**CITY OF TEMPE
DEVELOPMENT REVIEW COMMISSION**

**Meeting Date: 12/12/2017
Agenda Item: 4**

ACTION: Request for a Development Plan Review for a new six-story multi-family development containing 171 dwelling units and ground floor commercial uses for **FARMER ARTS DISTRICT – PARCEL 1, LOT 1**, located at 707 South Farmer Avenue. The applicant is Huellmantel & Affiliates.

WASTE REFUSE PLAN

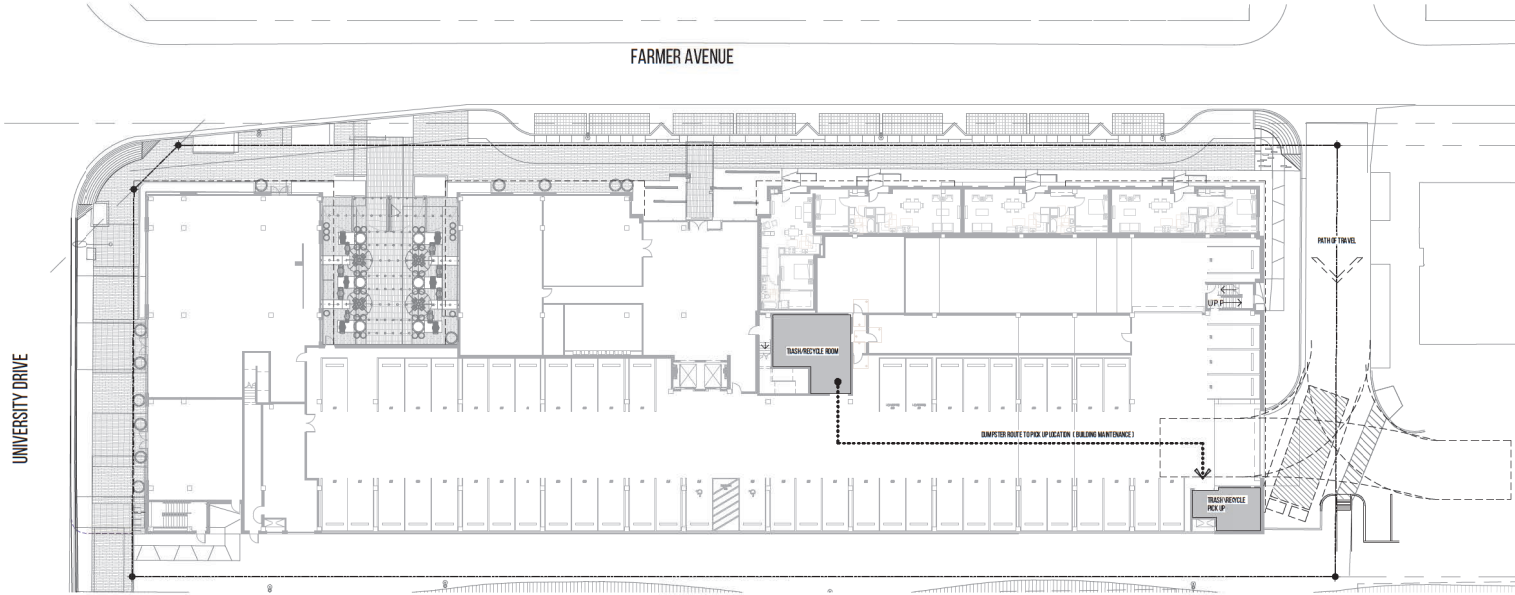
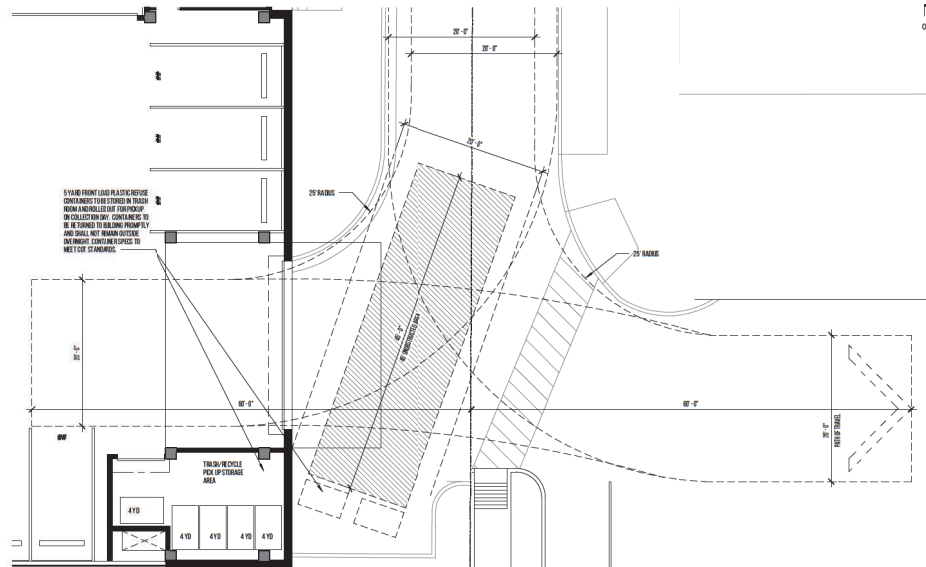
6. Refuse plan is approved as shown for both trash/recycle collection and staging for pick-up, on plan dated November 29, 2017 (Attachment 25, Sheet A-1.02).

FACADE DETAIL

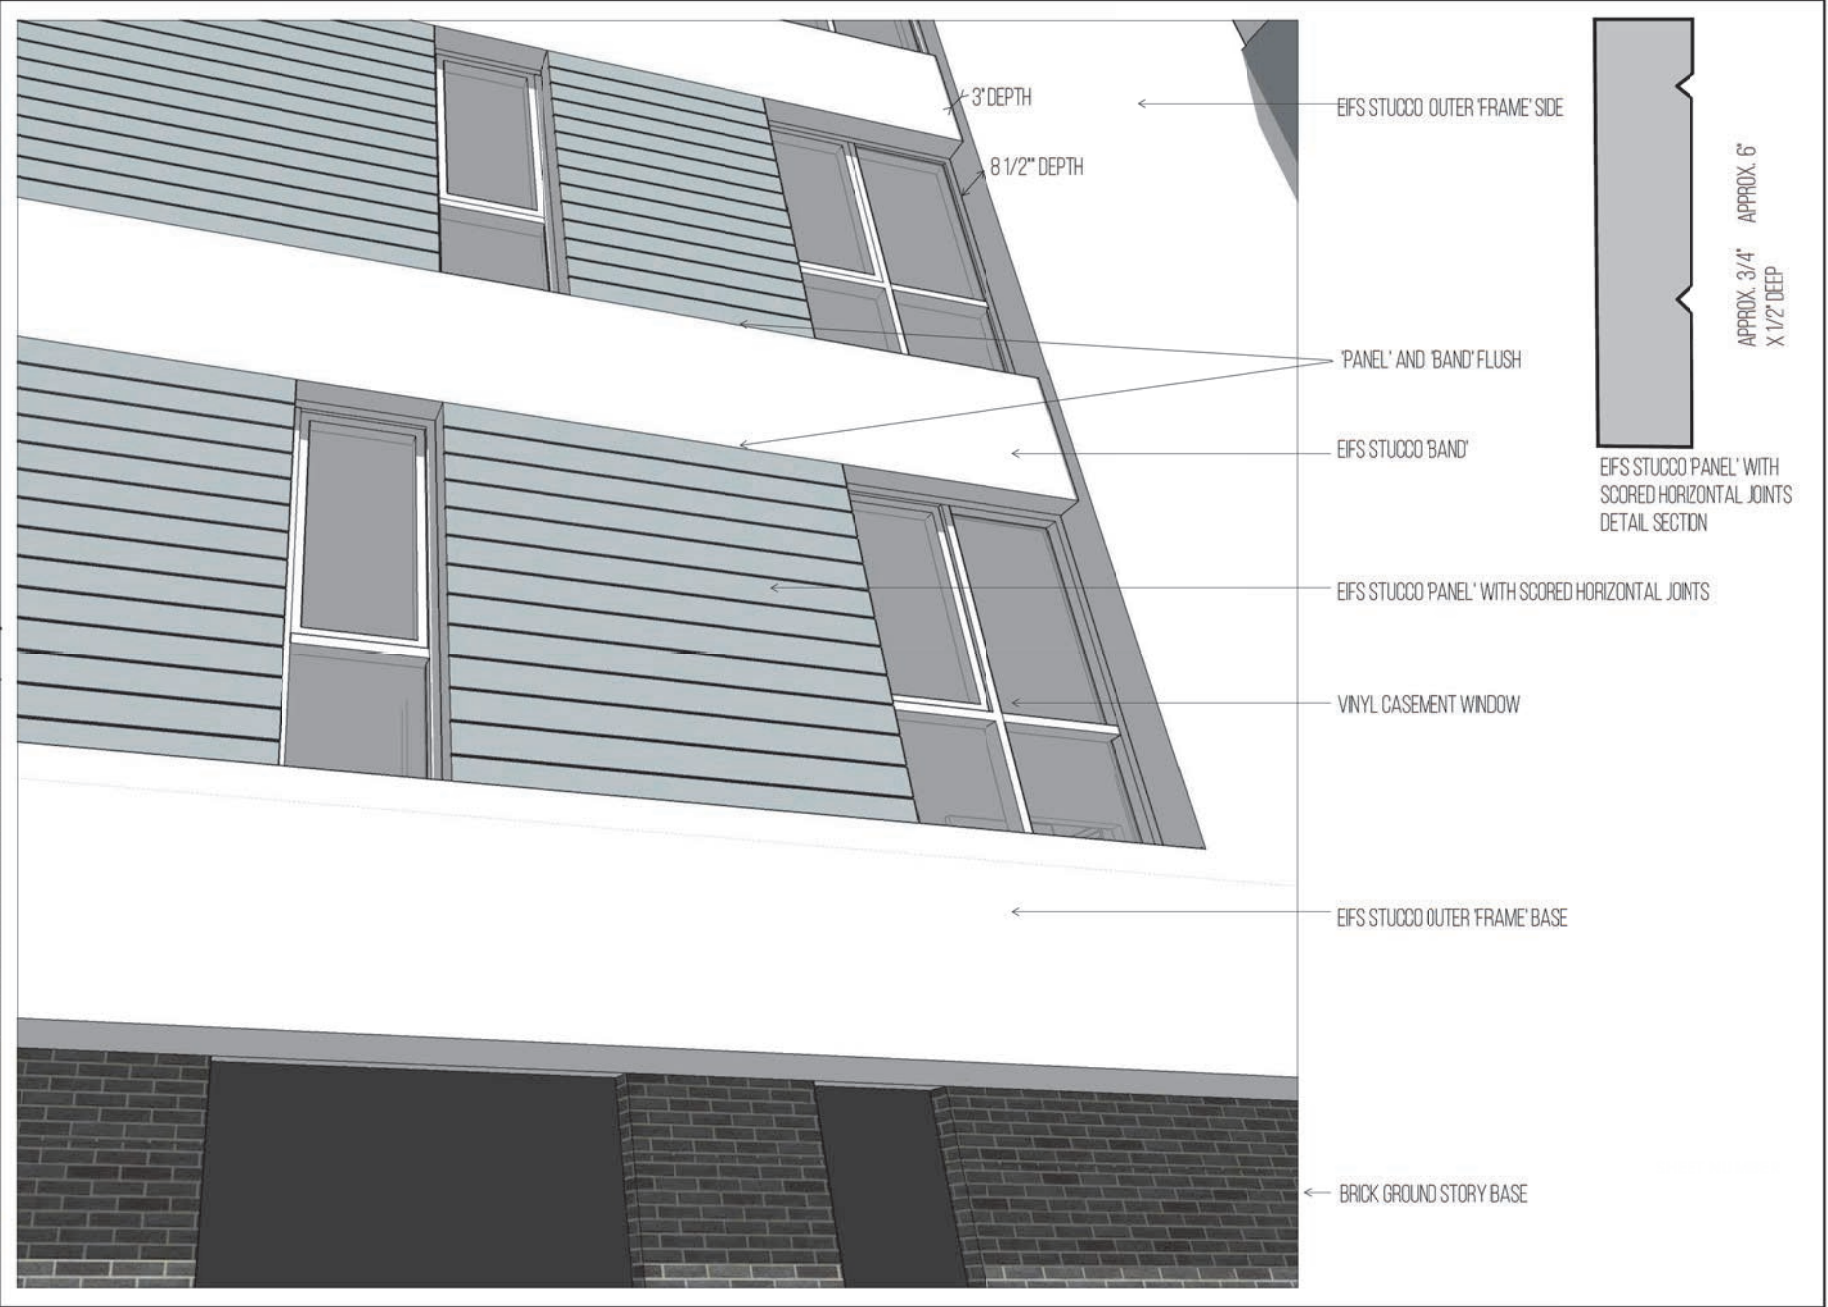
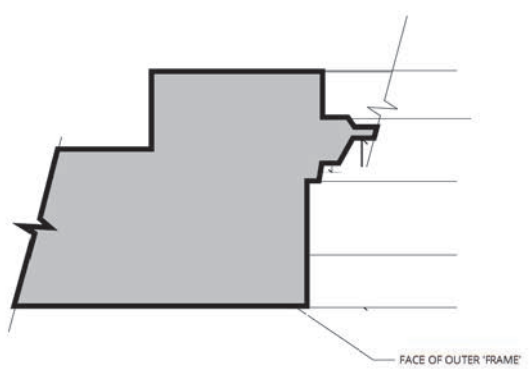
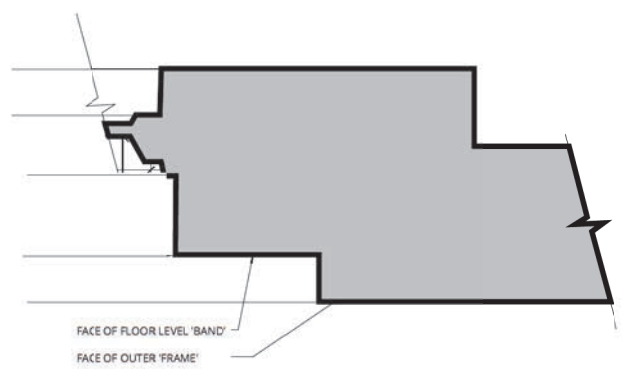
20. **Provide a minimum 5" and 8.5" deep recess to windows located on the south and west building façades. Refer to Attachment 33 (Sheet labeled Façade Detail) for compliance.**

21. **Portions of building where scoring is shown, must meet detail shown on Attachment 33 (Sheet labeled Façade Detail).**
22. Provide secure roof access from the interior of the building. Do not expose roof access to public view.
